Plat Name: Mary L. Kefauver's Subdivision – Bradley Hills
Plat #: 220111130

Location: Located on the south side of Armat Drive, 400 feet west of Burdette Road
Master Plan: Bethesda-Chevy Chase
Plat Details: R-200 zone; 1 lot
Community Water, Community Sewer
Applicant: New Classics - Sandy Spring Builders

SUBDIVISION RECORD PLAT
 LOT 22
**MARY L. KEFAUVER'S
 SUBDIVISION,
 BRADLEY HILLS**
 A RESUBDIVISION OF
 PART OF LOT 3
 BETHESDA (7TH) ELECTION DISTRICT
 MONTGOMERY COUNTY, MARYLAND
 SCALE: 1" = 30'

MINOR SUBDIVISION PLAT REVIEW SHEET

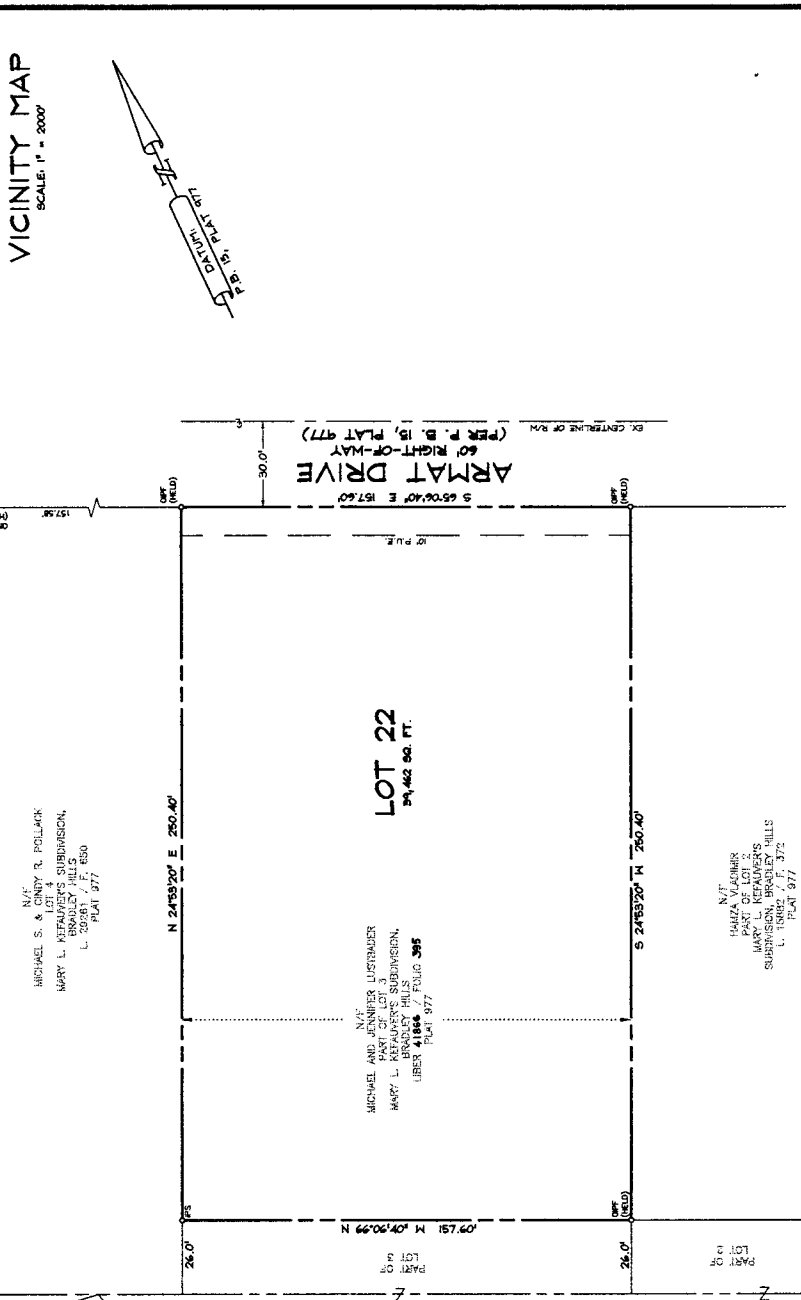
| Agency Reviews Req'd | Reviewer | Date Sent | Due Date | Date Rec'd | Comments |
|----------------------|---------------|-----------|----------|------------|--------------|
| Environment | Evelyn Gibson | 4-21-11 | 5-6-11 | 5-16-11 | NO REVISIONS |
| PEPCO | Bobbie Dickey | | | 4-29-11 | NO COMMENTS |

- a) Any prior subdivision conditions: _____
- b) Part of lot created by deed prior to June 1 1958: ok
yes 1941

Staff applied the above-noted minor subdivision criteria for the lot included in this application and concludes that the proposed subdivision complies with the requirements of Section 50-35A(a)(3) and supports this minor subdivision record plat.
